**Economic and Social Council**

Joint Meeting of Experts on the Regulations annexed to the European Agreement concerning the International Carriage of Dangerous Goods by Inland Waterways (ADN) (ADN Safety Committee)

Proposals for amendments to the Regulations annexed to ADN:**Other proposals****Proposal for the implementation of the modified concept for explosion protection on board inland waterway vessels****Transmitted by the Central Commission for the Navigation of the Rhine (CCNR)* ****

Classification of zones for tank vessels

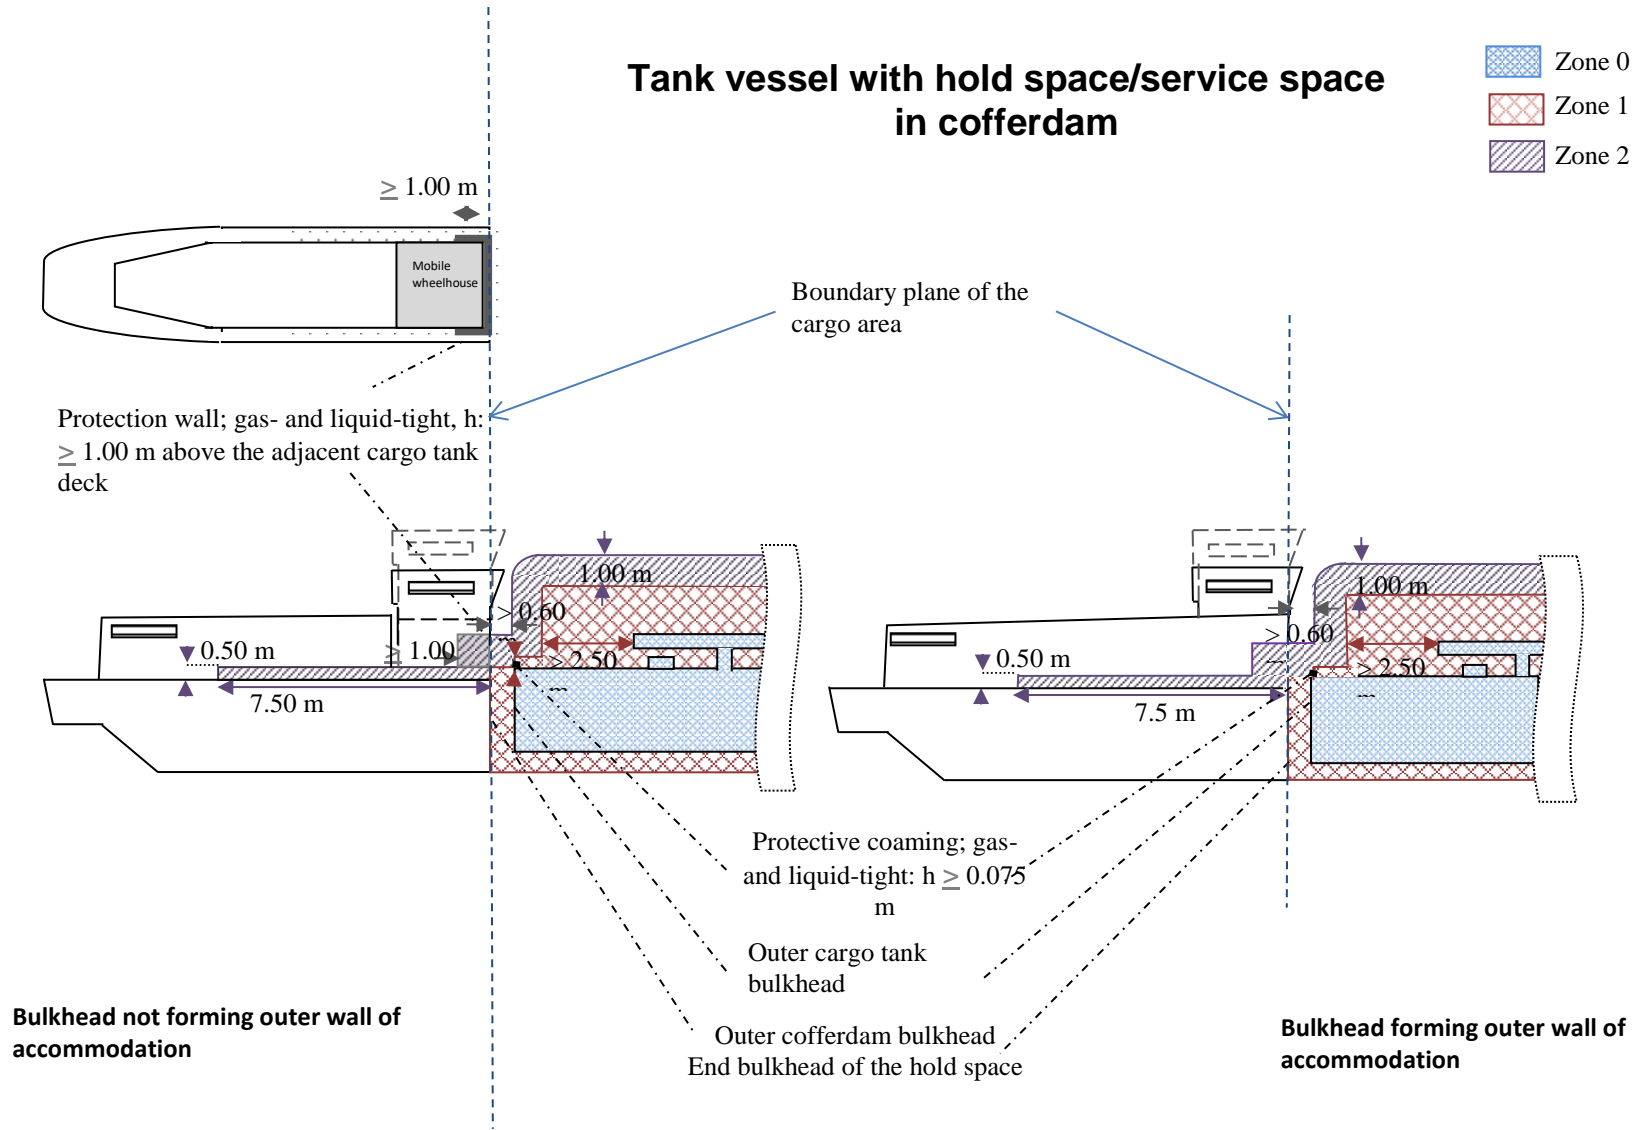
- All spaces located below deck in the cargo area not part of zone 0.
- Closed spaces on deck within the cargo area.
- The deck in the cargo area over the entire width of the vessel to the outer cofferdam bulkheads.
- Up to a distance of at least 1.60 m to the “boundary planes of the cargo area”, the height above the deck is 2.50 m, but at least 1.50 m above the highest piping carrying cargoes or cargo vapours.

If the ship is built with hold spaces or a cofferdam/ part of a cofferdam is arranged as a service space, the adjacent height (fore and aft) to the “boundary plane of the cargo area” is 1.00 m above deck (see diagram).

- On the deck in the cargo area, a zone extending 1.00 m upwards and joining zone 1 longitudinally.
- On the fore deck and the aft deck, an area 7.50 m in length across the entire width of the vessel and adjacent to the “boundary plane of the cargo area”. Between the lateral side of the vessel and the protection wall, the length and height of this area equals the dimensions of the lateral side of the protection wall. Elsewhere, the height in zone 2 is 0.50 m.
